Access Compliance Report

Public Rights-of-Way

(Curb Ramps)

Intersection ID: 19390	Main Street: VILLAGE_LAKE_DR	Cross Street: WOODSCAPE_DR	Location: SW
ADA ID: E37FC16BA3F4	Ramp Type: PerpDiag	Initial Pass/Fail: Fail	Overall Compliance: No
		Severity Score: 37.5

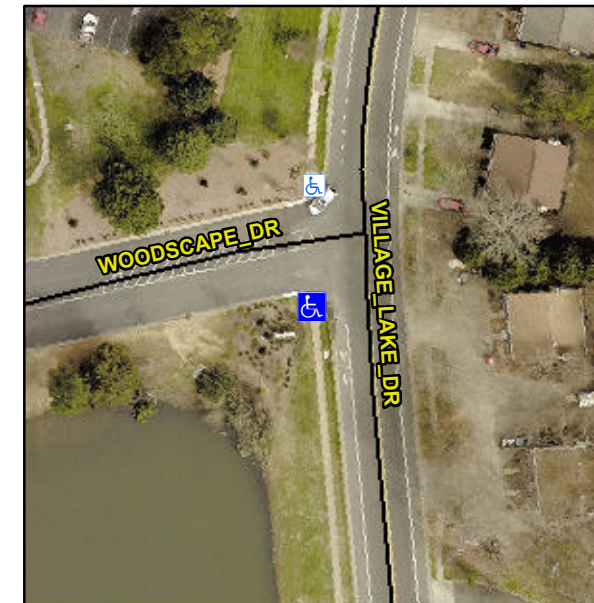
Not Found, R304.2.2, R304.5.3

Compliance	Description	Data	Compliance	Description	Data
N/A	Ramp Length (in)	56.0	No	Ramp Slope (%)	14.9
Yes	Ramp Width (in)	48.0	No	Ramp XSlope (%)	5.5
N/A	Flare Type LT	N/A	N/A	Flare Type RT	N/A
N/A	Flare Slope LT (%)	N/A	N/A	Flare Slope RT (%)	N/A
N/A	Flare Traversable LT?	N/A	N/A	Flare Traversable RT?	N/A
N/A	Landing Length (in)	N/A	N/A	DWS Provided?	N/A
N/A	Landing Width (in)	N/A	N/A	DWS Contrast?	N/A
N/A	Landing Slope (%)	N/A	N/A	DWS Length (in)	N/A
N/A	Landing X Slope (%)	N/A	N/A	DWS Full Width?	N/A
N/A	Landing Curb? (Y/N)	N/A	N/A	DWS Offset (in)	N/A
N/A	Shared Landing?	N/A			
N/A	Gutter Ponding?	N/A	N/A	Gutter Slope (%)	N/A
N/A	Gutter Lip Ht (in)	N/A	N/A	Gutter X Slope (%)	N/A
N/A	Painted X Walk1?	No	N/A	Painted X Walk2?	No
	X Walk 1 Direction	To E		X Walk 2 Direction	To N
N/A	X Walk 1 Width (in)	N/A	N/A	X Walk 2 Width (in)	N/A
	X Walk 1 Slope (%)	3.1		X Walk 2 Slope (%)	0.4
	X Walk 1 X Slope (%)	0.9		X Walk 2 X Slope (%)	3.4

Remove & Replace Curb Ramp With Two New Directional Ramps or Equivalent.
